ENGINEERING CHANGE NOTICE

1. ECN	166761
Page 1 of4	Proj. ECN

Interim-Status Ground-Water Monitoring Plan for the Grout Treatment Facility

Figure 3.1 Map Showing Location of Existing and Planned Wells at the Grout Treatment Facility

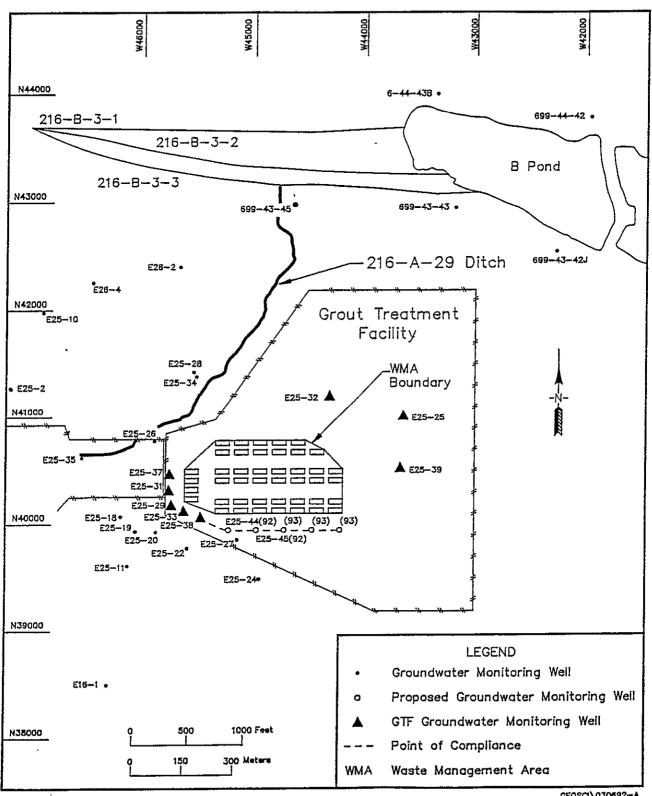
12. Descriptio						_			
		lowing paragra	ph to th	e section <u>Ins</u>	<u>tallati</u>	on of New			
		nitoring Wells:	nvonocod	for construct	tion al	ong the GTF point of			
						rells will be spaced			
						ne southwest of well			
E25-	38. The p	oint of compli	ance was	originally le	ocated .	40 ft south of the I	Waste		
						110 ft to the sout	h to		
						on (Figure 3.1). The			
						ıny statistically WMA will be immedia	talv		
		e proposed wel		e migrating is	· ···	nin niii be immedid	cery		
		г г г г г г г							
Continu	ed on page	e 3.							
27 1 1)	57	F	l	Co-ilitata Compt			
13a. Justificat			L. J.	Environmenta	[x]	Facilitate Const.	[]		
Design Error/On	mission []	Criteria Chang Design Improve	4.3	Environmenta As-Found	[]	Facilitate Const. Const. Error/Omission			
Design Error/On	mission []	Design Improve	ement []	As-Found	[]	Const. Error/Omission	[]		
Design Error/On 13b. Justificat To update 1	nission [] tion Details the Ground	Design Improve	ing Plan	As-Found on monitoring	[] y well p	Const. Error/Omission	[]

TPage 50-Figure 3.1, replace with attached Figure 3.1
